Access Compliance Report

Public Rights-of-Way

Intersection ID: 28103	Main Street: COMMUNITY_HOUSE_RD	Cross Street: PROVIDENCE_RD	Location: NE
ADA ID: D74705E93BD8	Ramp Type: Para	Initial Pass/Fail: Fail	Overall Compliance: No
Severity Score: 25			
Codes/Mitigation Info/Possible Solution		Field Measurements/Component Compliance

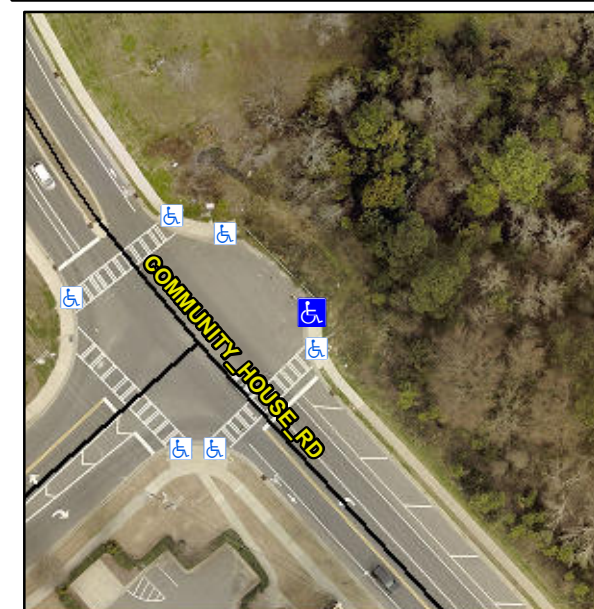
R304.3.2

Compliance	Description	Data	Compliance	Description	Data
N/A	Ramp Length LT (in)	67.0	N/A	Ramp Length RT (in)	60.0
Yes	Ramp Width LT (in)	59.0	Yes	Ramp Width RT (in)	57.0
Yes	Ramp Slope LT (%)	6.7	No	Ramp Slope RT (%)	14.5
Yes	Ramp XSlope LT (%)	1.6	Yes	Ramp XSlope RT (%)	1.3
N/A	Landing Length (in)	N/A	N/A	DWS Provided?	N/A
N/A	Landing Width (in)	N/A	N/A	DWS Contrast?	N/A
N/A	Landing Slope (%)	N/A	N/A	DWS Length (in)	N/A
N/A	Landing X Slope (%)	N/A	N/A	DWS Full Width?	N/A
N/A	Landing Curb? (Y/N)	N/A	N/A	DWS Offset (in)	N/A
N/A	Shared Landing?	N/A			
N/A	Gutter Ponding?	N/A	N/A	Gutter Slope (%)	N/A
N/A	Gutter Lip Ht (in)	N/A	N/A	Gutter X Slope (%)	N/A
N/A	Painted X Walk1?	No	N/A	Painted X Walk2?	N/A
	X Walk 1 Direction	To NW		X Walk 2 Direction	N/A
N/A	X Walk 1 Width (in)	N/A	N/A	X Walk 2 Width (in)	N/A
	X Walk 1 Slope (%)	1.2		X Walk 2 Slope (%)	N/A
	X Walk 1 X Slope (%)	0.1		X Walk 2 X Slope (%)	N/A
N/A	Ramp inside XWalk1?	N/A	N/A	Ramp inside XWalk2?	N/A

Remove & Replace Entire Ramp.
